## ADDENDUM NO. TWO

BID TITLE: **Bid No. 6301 – Arvin High School Modernization: Phase 1A Roofing**

**Arvin High School Phase 1A Roofing**

**ADDENDUM NO. 05**

P1.11

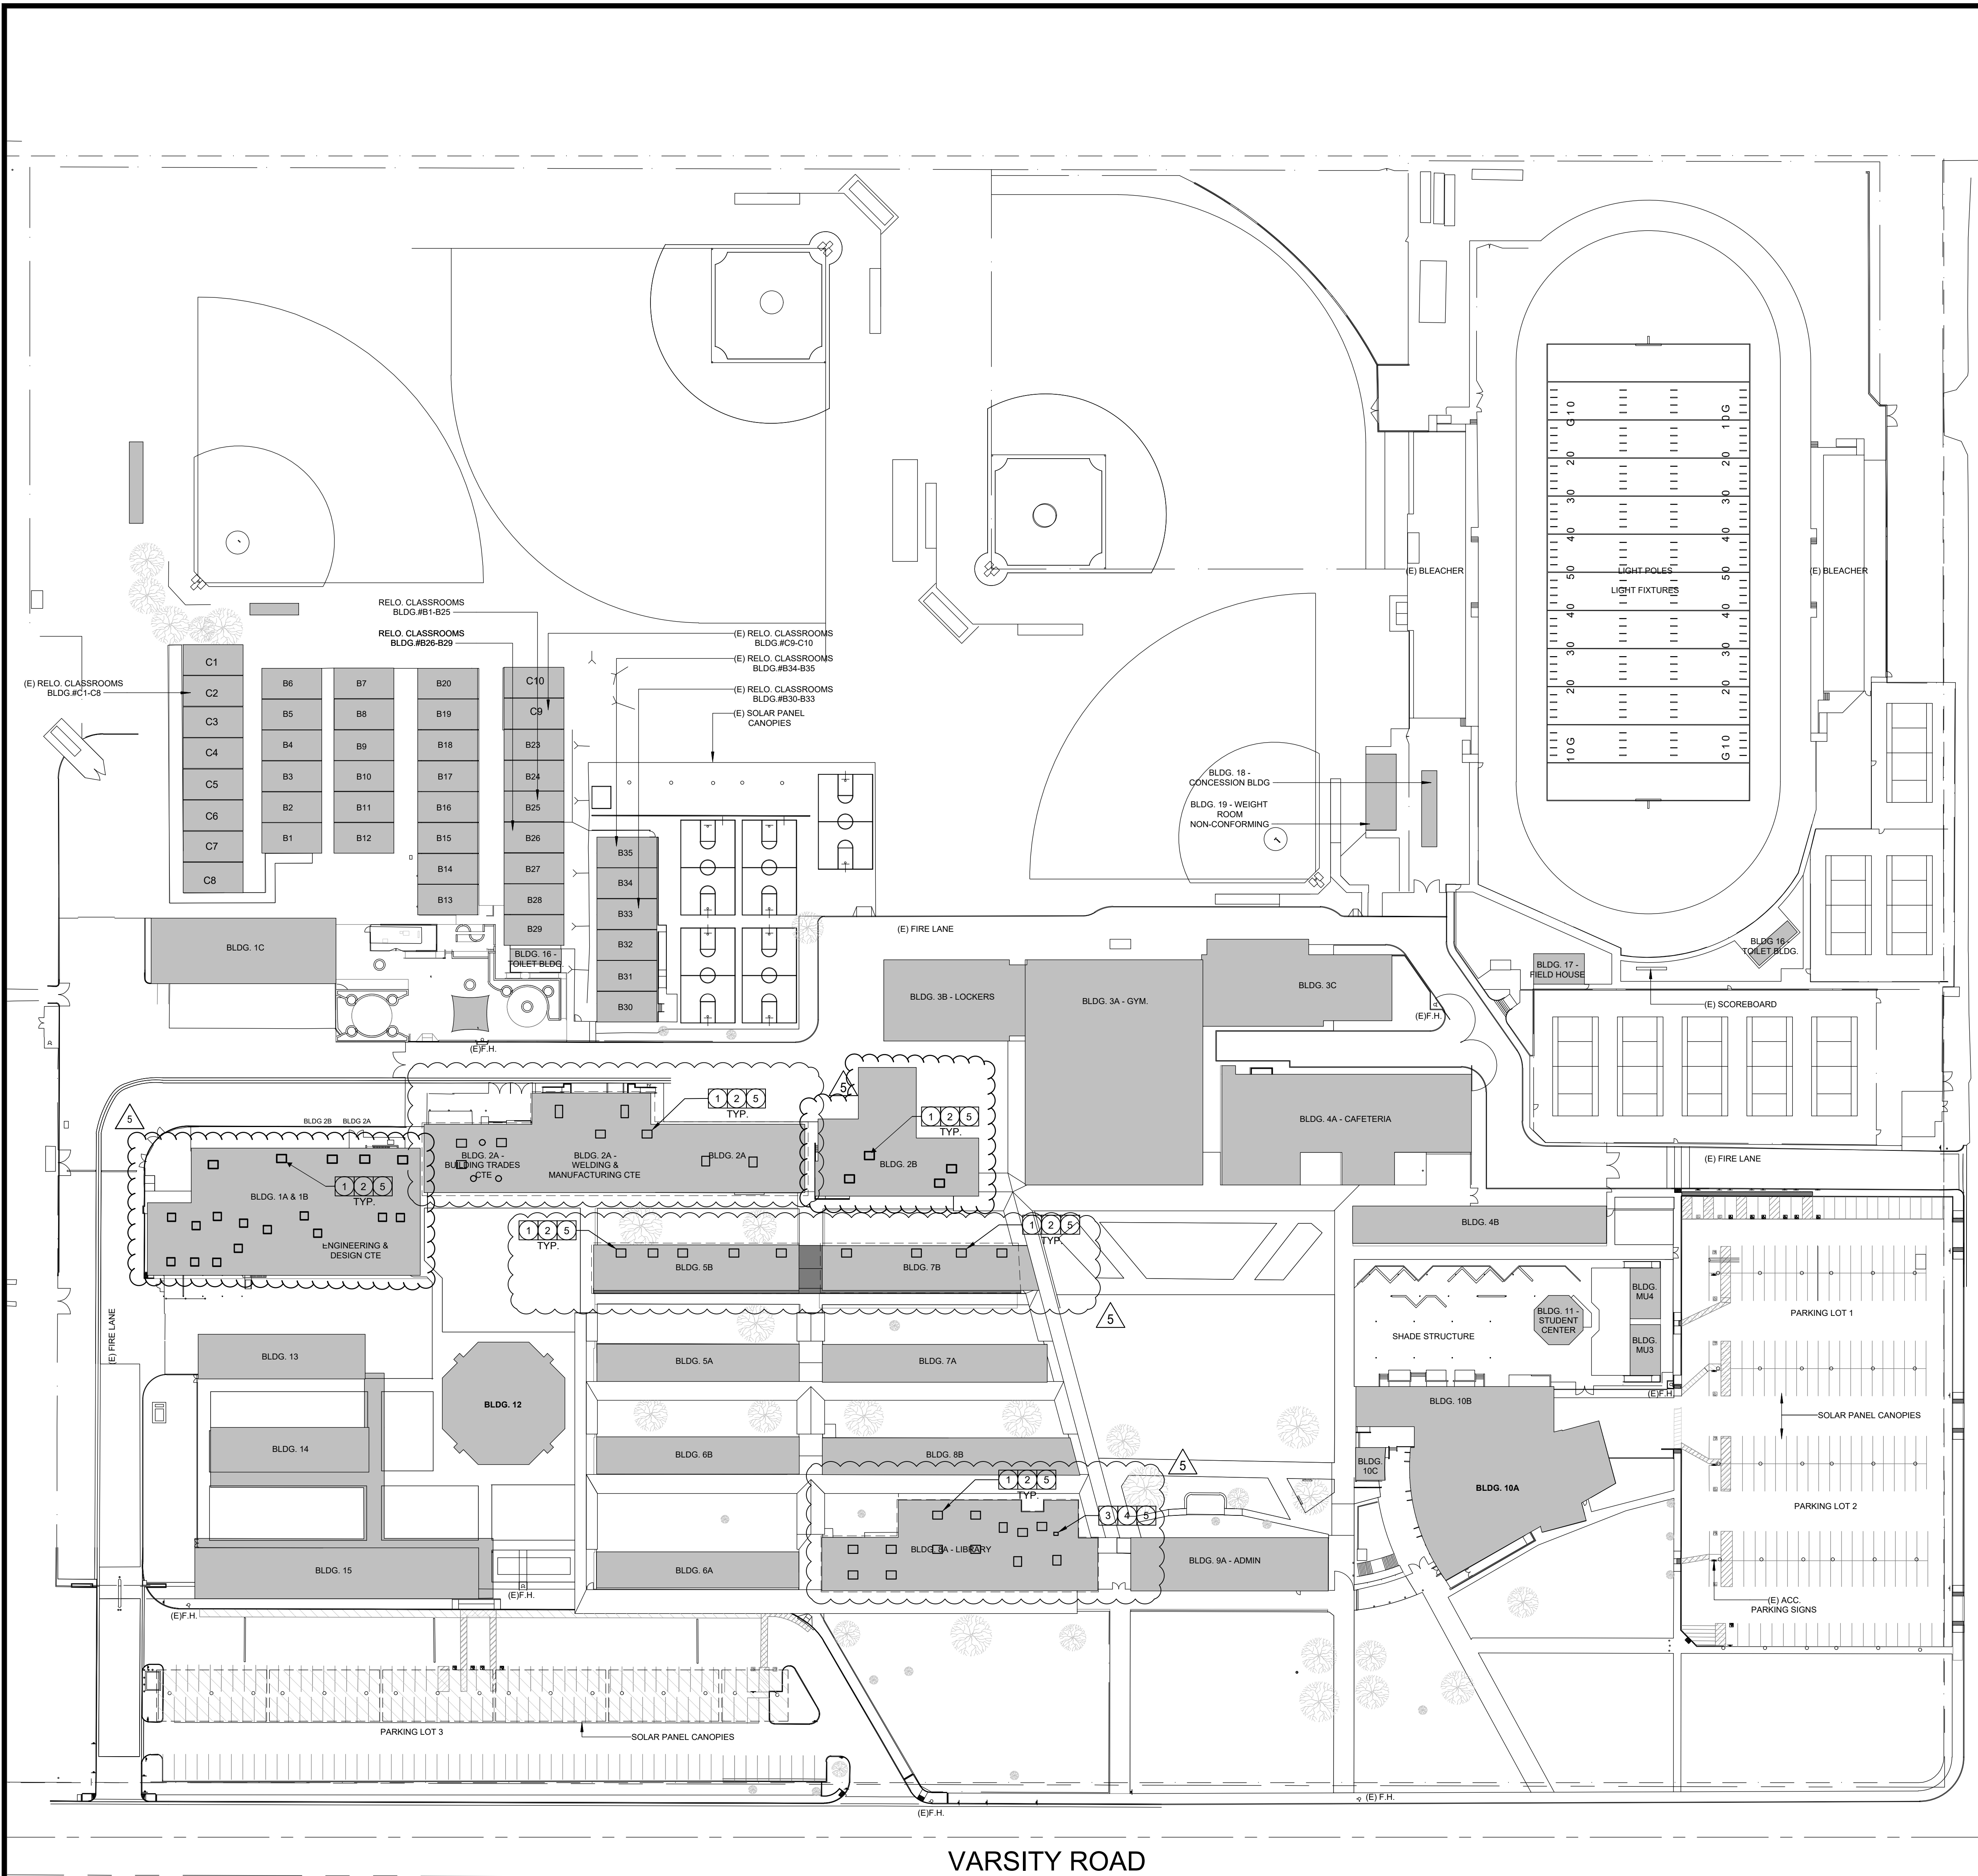
- 1.) ADD Plan notes 3, 4 and 5 as shown and clouded per Delta 5.

- 2.) ADD General notes as shown and clouded per Delta 5.
- 3.) ADD Plan notes to buildings 1A, 1B, 2A, 2B, 5B, 7B and 8A as shown and clouded per Delta 5.
